**IFB NO. 500630-FY22-18  
WATER FILTRATION PLANT (WFP)  
FILTERS 1 & 2 REHABILITATION PROJECT**

**ADDENDUM NO. 6**

**APRIL 5, 2022**

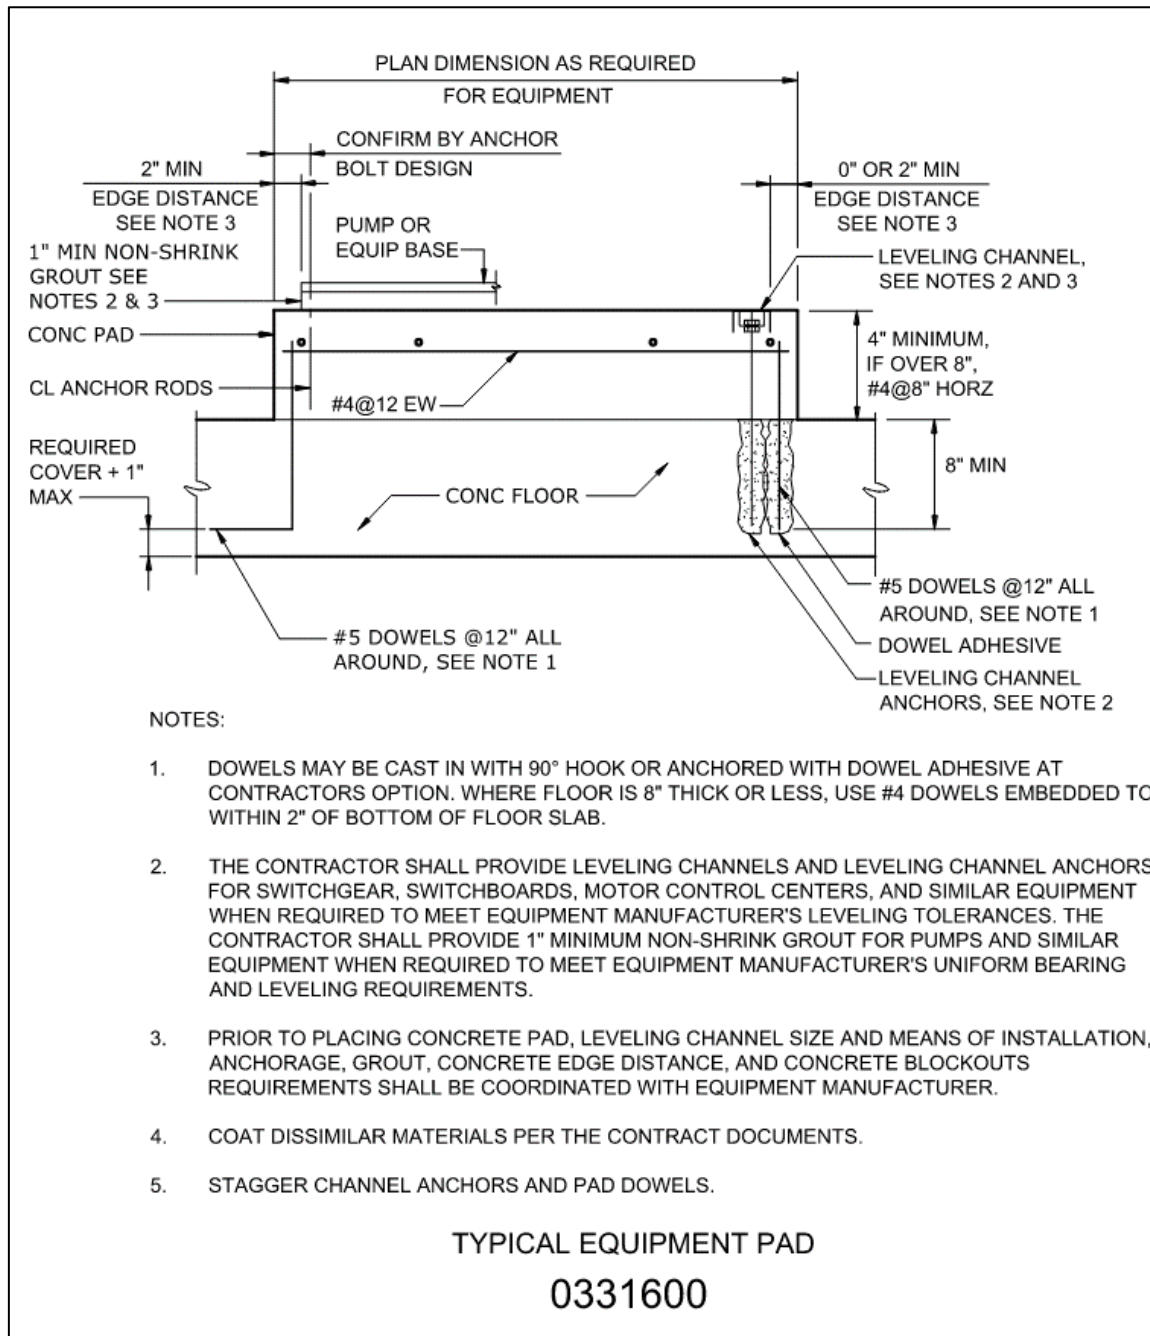
1. There is no Sheet 28 (Sheet 28 is missing from Drawing G2). This sheet number was inadvertently skipped.
2. Make the following Sheet Number changes:
  - a. Drawing EE1 – Sheet 19.
  - b. Drawing EE2 – Sheet 20.
  - c. Drawing EE3 – Sheet 21.
  - d. Drawing EE4 – Sheet 22.
  - e. Drawing EE5 – Sheet 23.
  - f. Drawing EE6 – Sheet 24.
  - g. Drawing EE7 – Sheet 25.
  - h. Drawing EE8 – Sheet 26.
  - i. Drawing EE9 – Sheet 27.
  - j. Drawing I1 – Sheet 29.
  - k. Drawing I4 – Sheet 32.
3. Drawing E3 – **ADD** the following detail to this sheet:

32. Can a detail be provided for the new concrete pad shown on page E3?

**RESPONSE: Detail for the equipment pad is shown below.**

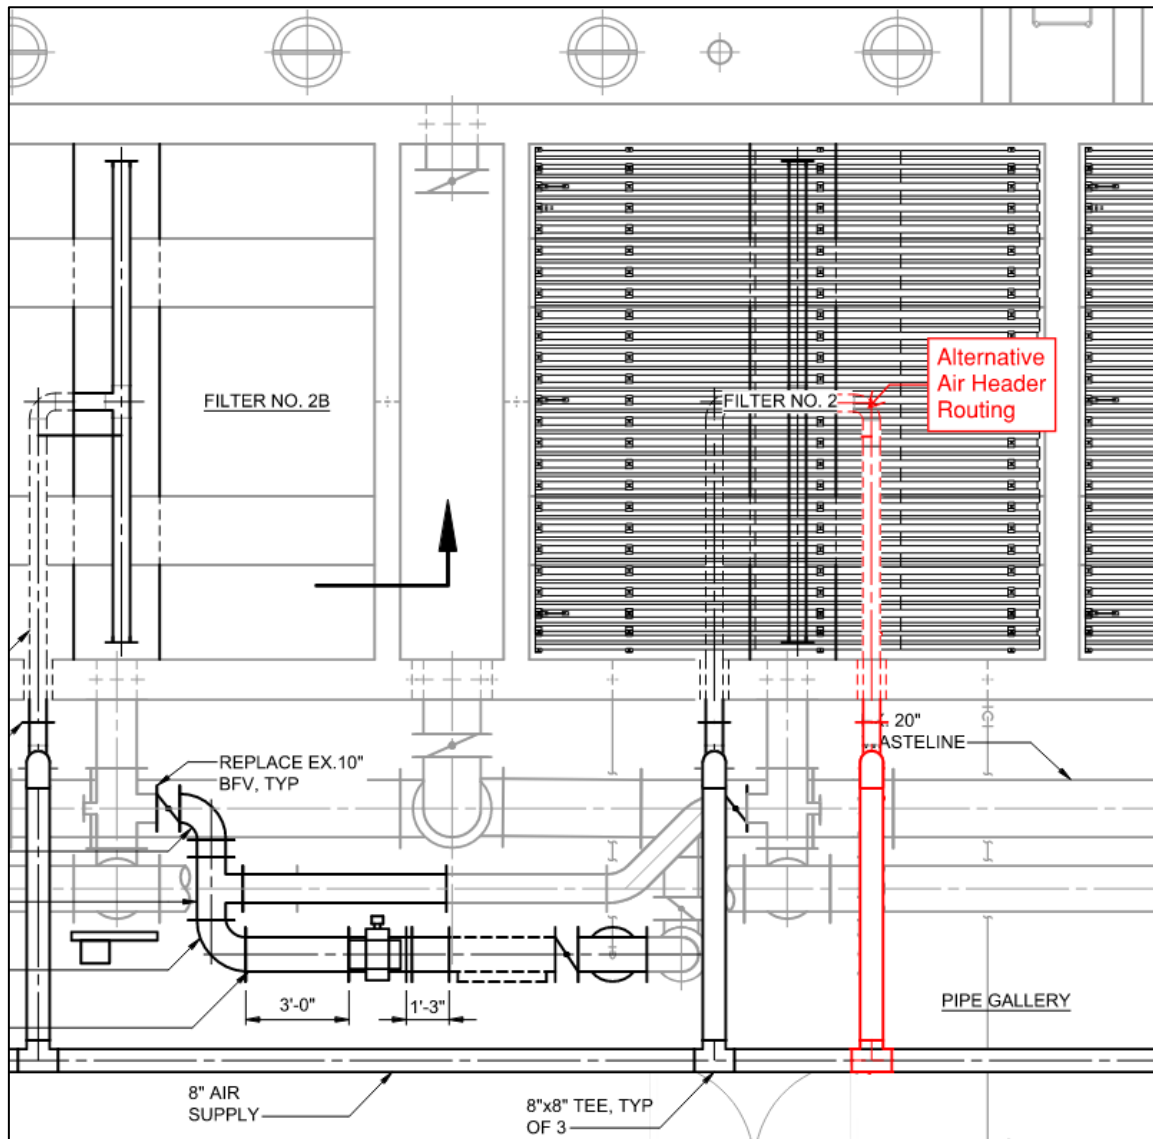
38. During our site visit, it was noted that electrical components, chemical lines, and a valve actuator potentially interfere with the location of the new blower piping for Filter No. 1A. Similar conditions exist at Filter No. 1B, 2A, and 2B. Is the contractor responsible for relocating these utilities?

**RESPONSE: The new blower piping can be located on either side of the existing filter effluent piping. Alternative air header routing is shown below. The Contractor shall be responsible for relocating/rerouting of the existing utilities, as deemed necessary, for a fully functioning system. Relocations shall be coordinated with the Town and Engineer for review and approval.**
